# FINAL PLAT THE TRAILS FILING No. 10

A SUBDIVISION OF PORTIONS OF THE SOUTHWEST QUARTER OF SECTION 16 AND THE SOUTHEAST QUARTER OF SECTION 17,  
TOWNSHIP 12 SOUTH, RANGE 64 WEST OF THE THE SIXTH PRINCIPAL MERIDIAN, COUNTY OF EL PASO, STATE OF COLORADO.

PCD FILE No. SF-24-21  
Sheet 1 - Description, Dedication, Notes and Certificates  
Sheet 2 - General Notes  
Sheet 3 - Plat Graphic, Residential Lots  
Sheet 4 - Plat Graphic, Residential Lots  
Sheet 5 - Plat Graphic, Residential Lots

Sheet 3 of 5

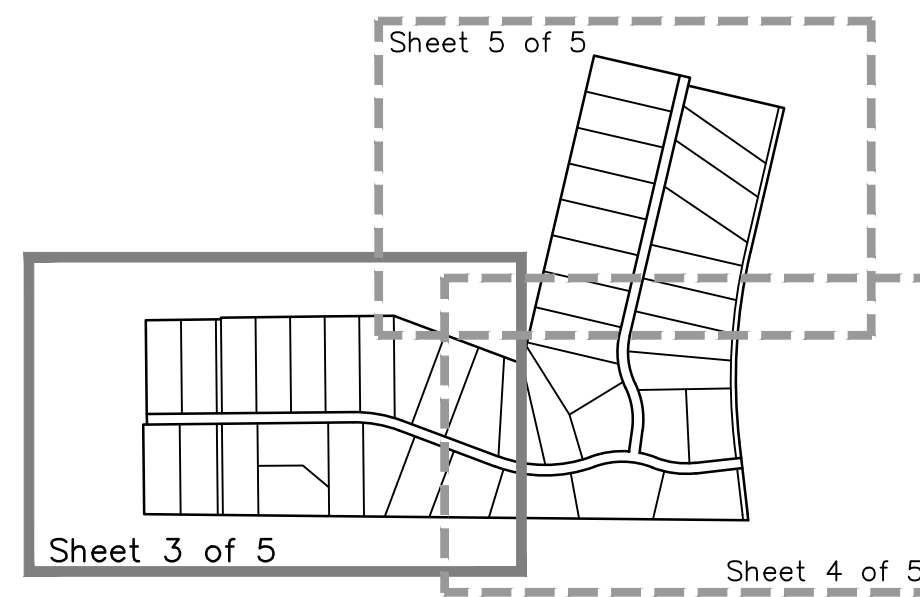
- Fire hydrants will need to be implemented at the site. Please indicate where the fire hydrants will be. (Section 6.3.3.C.1.c)
- Drainage easements are tied to no build areas, this should be depicted on the plat
- Please include trail easement that has been requested from EPC Parks Dept

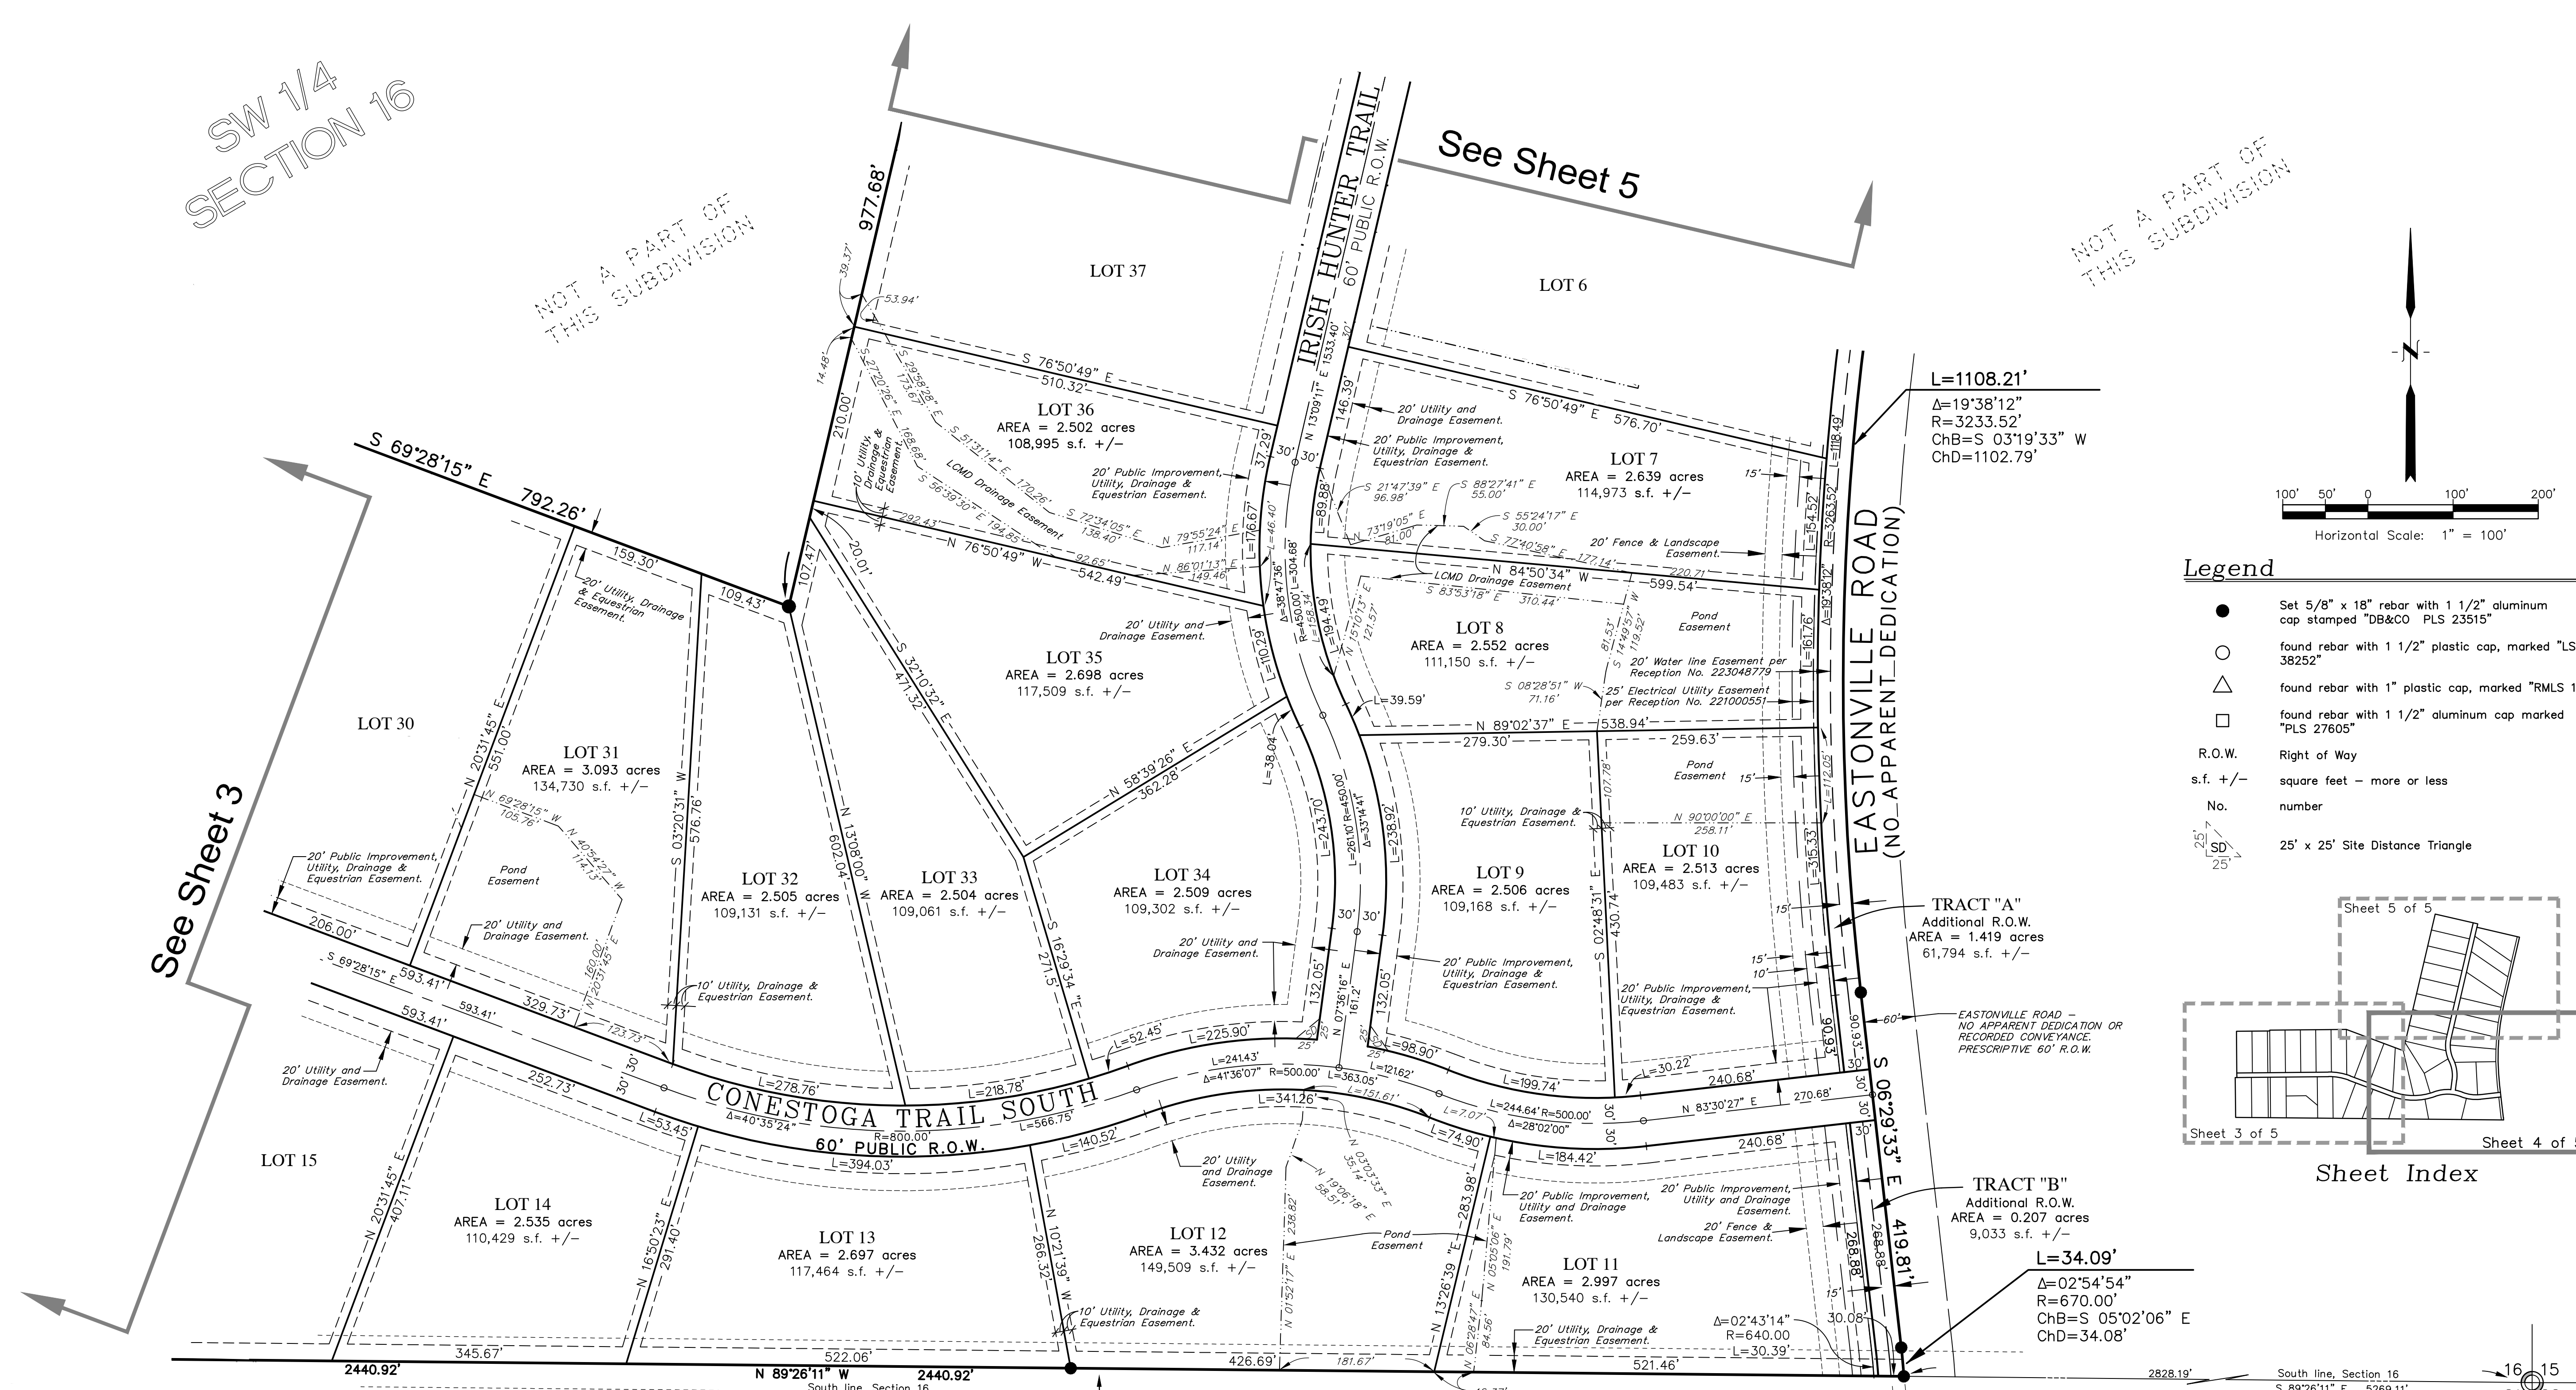
please provide a reception number for the equestrian easement here or with plat note 31
